McCormick, Paulding & Huber LLP
Title: SIDE BEARING PAD
Applicant: Richard L. Palinkas
Serial Number: 09/407,053
Attorney Docket Number: 6350-05

## Replacement Sheet

FIGURE X

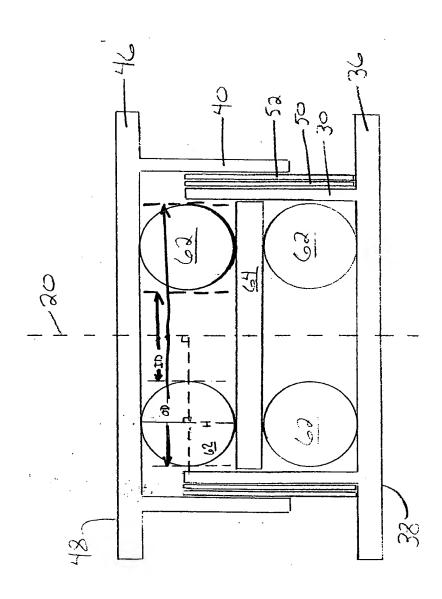
The Examiner has objected to amended Figure 2 filed on June 13, 2002 with respect to the dimensions of the toroidal springs 62 identified therein. An amended Figure 2 is submitted herewith on the attached replacement sheet. Figure 2 is amended herein to correct the dimension lines identifying each of the inner and outer diameters of the toroidal ring 62 shown therein. Accordingly, the Examiner's objection to Figure 2 should be withdrawn.
